Oyster Creek Generating Station
Facility Operating License No. DPR-16
NRC Docket No. 50-219

Subject: Proposed Relief Requests to the Requirements of 10CFR50.55a
Concerning the Third Ten-Year Interval Inservice Inspection Program
Response to Request for Additional Information

REVISED RELIEF REQUESTS

OC-32
OC-33
OC-34
OC-35

FIGURE 1
Relief Request OC-34
TYPICAL INNER RADIUS SCAN

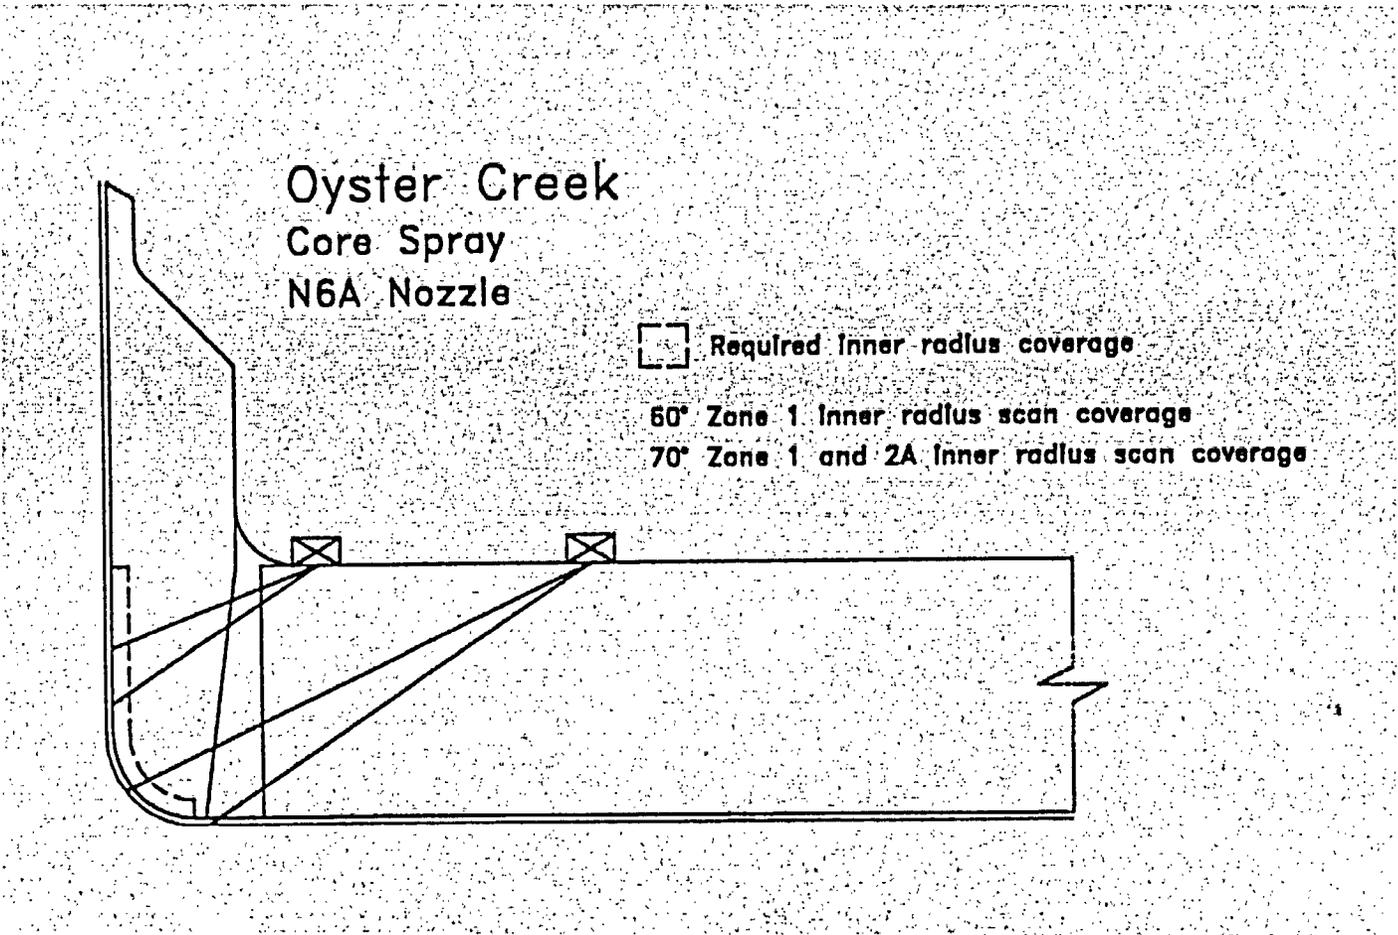
Oyster Creek has twenty-four Reactor Vessel nozzles that apply to this B-D examination category. Due to the nozzle forging configuration and access restrictions, portions of the Code required examination volume can not be completely examined with automated or manual techniques. The curvature of the blend radius of several nozzle forgings are such that ultrasonic scanning of the weld is interrupted due to loss of contact of the ultrasonic search unit. This limitation affects both transverse and parallel scanning of the Code required examination volume. The nozzle and vessel material is carbon steel that is typically not susceptible to IGSCC or other typical degradation mechanisms at a BWR. An Oyster Creek service history review found that no outside nozzle and vessel surfaces are exposed to wetting from concentrated chloride bearing environments. Also, in support of ALARA, many of the nozzle to vessel welds are examined utilizing a remote automated nozzle scanner. These techniques however, further limit the examination coverage due to scanning limitations caused by scanner design. Attached Figures 1 and 2 provide a typical example of a limited nozzle examination.

FIGURE 3
Relief Request OC-34
CRD Return Nozzle Interferences

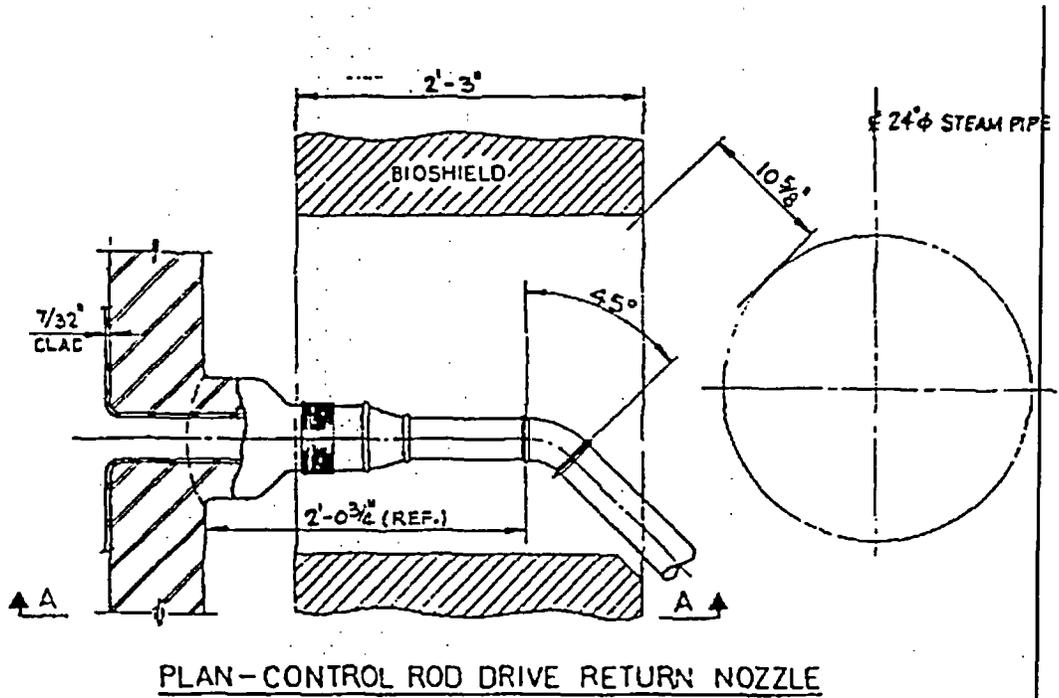
The CRD return nozzle (N9) is still utilized for return flow to the reactor at Oyster Creek. The nozzle internal thermal sleeve was replaced with an improved design that protects the nozzle ID surfaces from thermal fatigue by not allowing the return flow to contact the nozzle ID surfaces. The nozzle ID is inaccessible for an EVT-1 examination due to access limitations. Figure 3 provides a diagram of this return nozzle.

Diagram 104R858

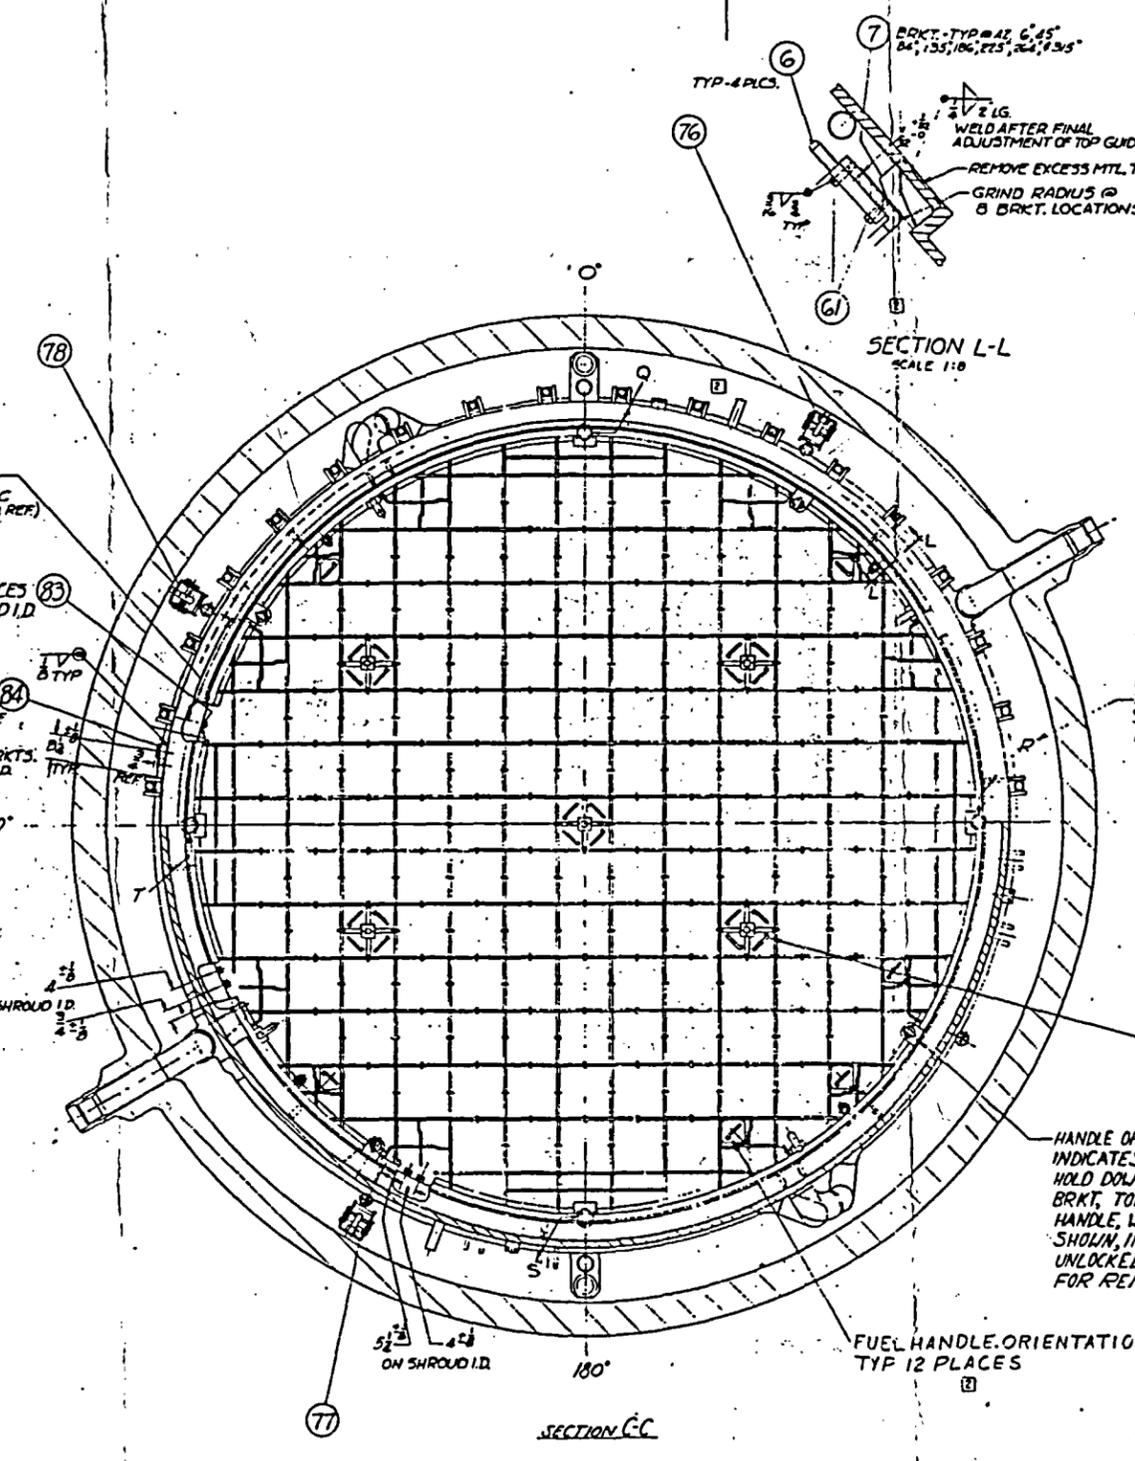
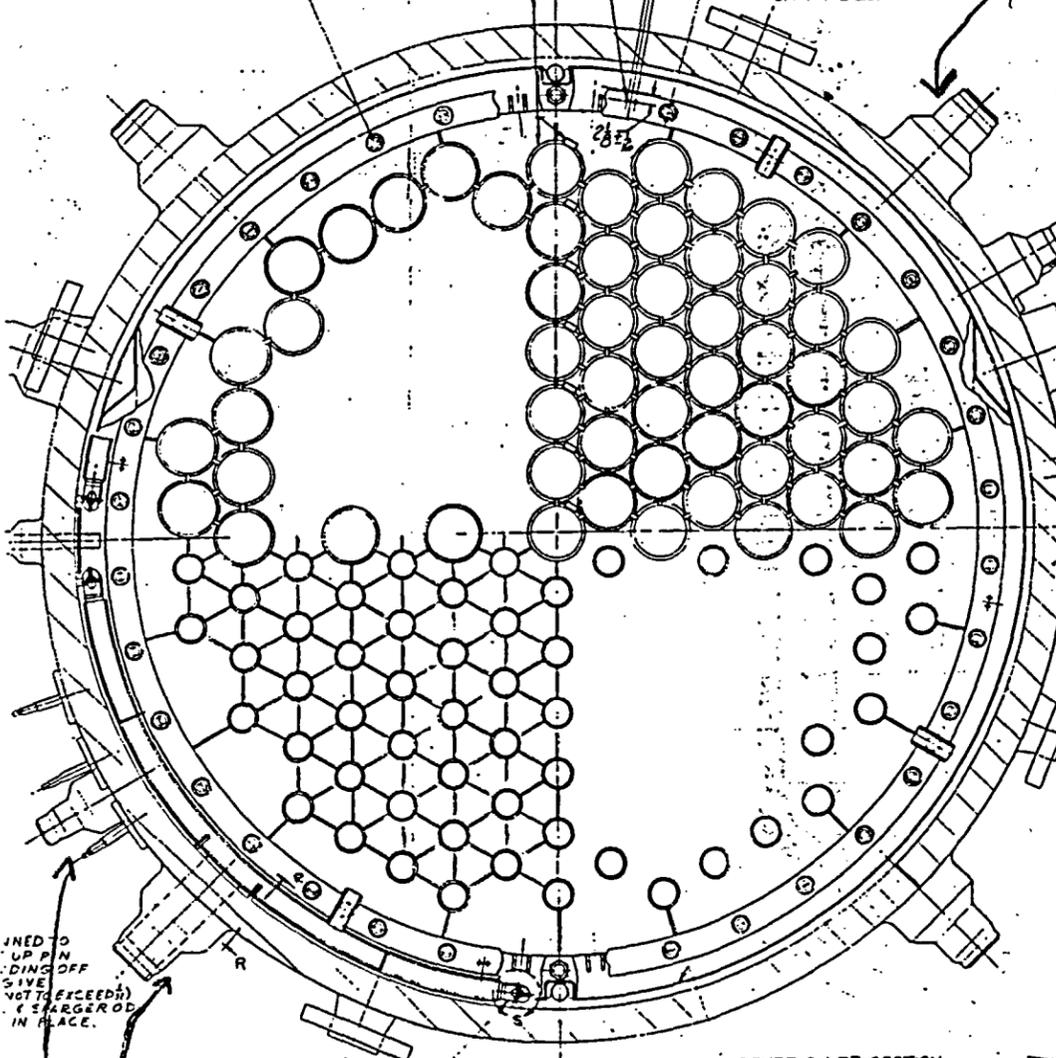
Also attached is drawing 104R858, which provides an overhead view of the vessel. This diagram is an example of the close proximity of the Core Spray and Feedwater nozzles to each other. This close proximity results in limited coverages for the nozzle examinations, as shown in the coverages presented in the previous Table.
